## File Note: Notice of Requirement

SR462159 East Side Airport - Notice of Requirement

## Three Waters Comments

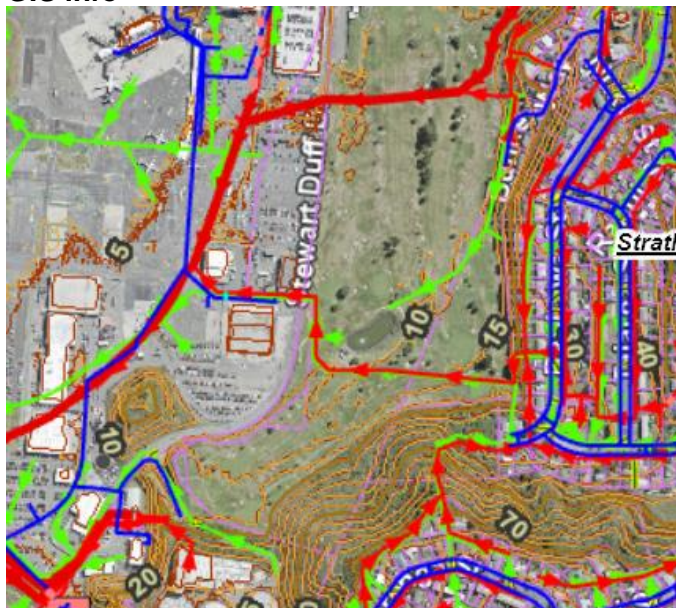
A number of Council services run through the proposed designation site. The location of these services is shown in **Appendix H** attached and includes:

- A 375mm diameter wastewater trunk main, running approximately parallel with the northern boundary of the proposed designation site;
- A network of 750mm stormwater pipes originating from Ruakawa Street and Bunker Way; and
- A 150mm wastewater main originating from Ruakawa Street.

There is an existing 375mm sewer pipe currently being investigated for upgrade and renewals by Wellington water.

There may be potential issues regarding relocation of the above infrastructure.

#### Water Supply:

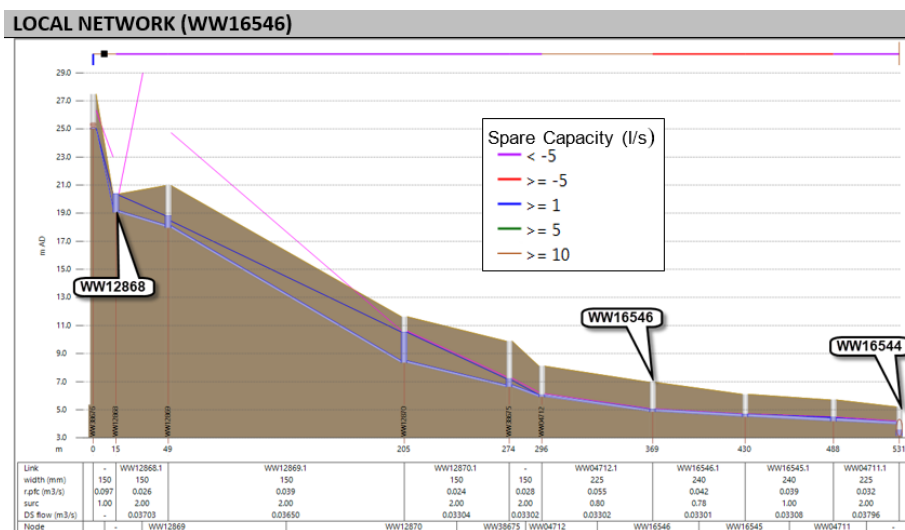
The airport has dual feed of 200mm pipes for water supply. One from Stewart Duff Drive and the other from Moa Point Road. The model shows that minimum pressure around the identified zone is expected to be about 65-70m. The model also indicates that available combined fire flow capacity from the existing hydrants is expected to be around 100 L/s.

This modelling assessment only represents the existing network based on WWL hydraulic model developed in 2019. The analysis takes no account of other developments that have occurred since then, currently underway, or future developments. Non-hydraulic parameters like pipe age, conditions and likelihood of their failure have not been assessed. Please also note the above are just the result of WWL hydraulic model which could be impacted by day-to-day operational changes within the network and may need to be verified in the field through pressure logging and hydrant flow tests.

- Once final scheme plan is defined, the applicant is recommended to have further discussion with Wellington Water, to obtain water supply advice and the most up to date modelling information.

Depending on the actual needs of the proposed buildings, the applicant is recommended to discuss with Fire and Emergency New Zealand regarding the fire risks and mitigation measures.

- Prior to the commencement of any works, the consent holder will be required to provide to Wellington Water Land Development Team for review and approval, a design statement endorsed by a Chartered Professional Engineer on:

Calculations, specifications and design plans to confirm that there is sufficient water supply pressure and flow for the development to meet the Wellington City Code of Practice for Land Development 2012.

Calculations based on pressure logging (for a minimum one week period) and flow readings taken from the nearest hydrant.

## TRUNK NETWORK (pipes 300mm dia and above)

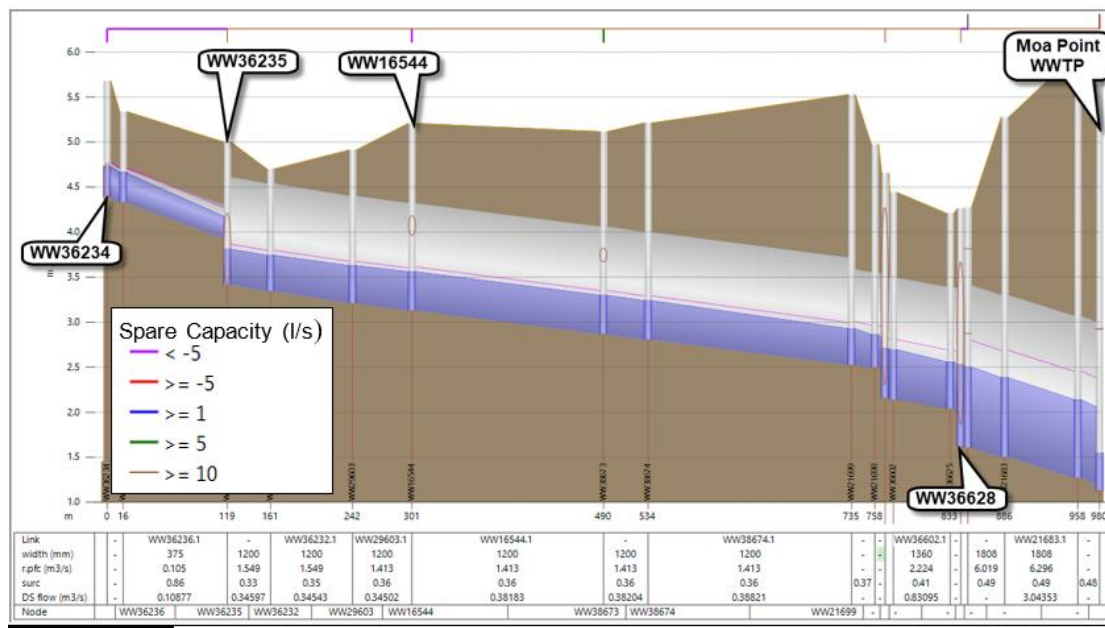
The site can be potentially connected to the local network at, or downstream of manhole WW16546 that discharges into the trunk network at manhole WW16544. This part of the local network has several sections that are at, or over their design capacity during a 1-year LTS design event. Furthermore, there is an overflow at manhole WW12868 (approx. 350m upstream of manhole WW16546) that is predicted to spill approximately 5 m<sup>3</sup> during that design event. Connecting the terminal expansion to this local network and further development of this site could exacerbate this.

The trunk network downstream of manholes WW36234 and WW16544 ultimately discharges to the Moa Point WWTP. Between manholes WW36234 and WW36235 (representing about 119m of this system), as well as the 7m downstream of manhole WW36628, this trunk network is already over its design capacity during a 1-year LTS design event. The remainder of this trunk network (approx. 854m) has at least 10 litres/sec of spare design capacity during the same design event. The most appropriate location to connect the terminal expansion would be to this trunk network between manholes WW36235 and WW16544 where there is sufficient capacity and the additional flow is least to cause increased overflows upstream in the local and trunk networks.

This assessment is based on the results from WWL hydraulic models. It does not take into account the impact on the spare design capacity of other developments that have occurred since then, are currently underway, or possible future developments. Non-hydraulic parameters like pipe age, conditions and likelihood of their failure have not been assessed. Flow monitoring may be required to verify these results. This development may impact on the spare design capacity available for possible future developments along the downstream network.

- Once final scheme plan is defined, the applicant is recommended to have further discussion with Wellington Water on the connection requirements, and obtain wastewater advice and the most up to date modelling information.

- The existing 375mm sewer pipe crossing the site is currently being investigated for upgrade and renewals by Wellington Water. The other local network on site is also shown to be under capacity.

Due to existing wastewater pipe capacity issues, and potential pipe relocation requirements, we recommend future wastewater connections to be made to the network between manholes WW36235 and WW16544 where there is sufficient capacity and the additional flow is less likely to cause increased overflows upstream.

- Wastewater pipe upgrades or sewer mitigation (i.e., storage and pumping) is likely to be required for this site.
- The applicant shall discuss with Wellington Water on the treatment of the existing wastewater mains on site:
  - a. Wastewater pipe relocation will be required on site. Any public main related works will require a Public Drainage Permit. Detailed design shall also be provided by the applicant.
  - b. Based on the Regional Standard for Water Services (May 2019), where a building or retaining wall already exists, public drains shall not be laid within 1.5m of the building or retaining wall. Where a pipe is laid deeper than 1.5m, a building restriction line shall be defined (refer to 4.4.14 of standard for details).
  - c.
- Please note, depending on the final scheme, trade waste consent may be required.

### Stormwater:

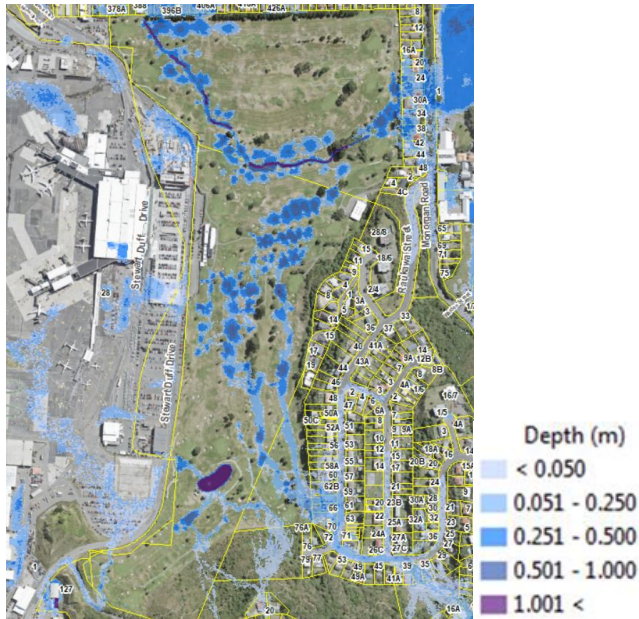
Based on draft Miramar model (1% AEP event including climate change), there are minor flows and moderate ponding on the golf course. Due to uneven terrain of the site, the flooding water level would vary between 4.5 m aMSL and 15 m aMSL (levels of hills are not included).

- Once final scheme plan is defined, the applicant is recommended to have further discussion with Wellington Water on the connection requirements, and obtain stormwater advice and most up to date modelling information.
- There appears to be a reasonable sized stormwater detention facility on site, relocation of the pond need to be assessed and discussed with Wellington Water.
- The applicant is recommended to discuss with Wellington Water on the recommended minimum floor levels at the future building site (note that this level would vary depending where on site construction is proposed and should be to the underside of the concrete slab or floor timber joist).
- Due to flooding downstream, stormwater neutrality (1% AEP based on current practice) will be required on site to avoid impact on downstream flooding.
- Stormwater treatment will be required.

- There are several overland flow paths that cross the property boundary of the site. These will have to be assessed in detail to avoid blocking them and potentially exacerbating flooding upstream or on the site.
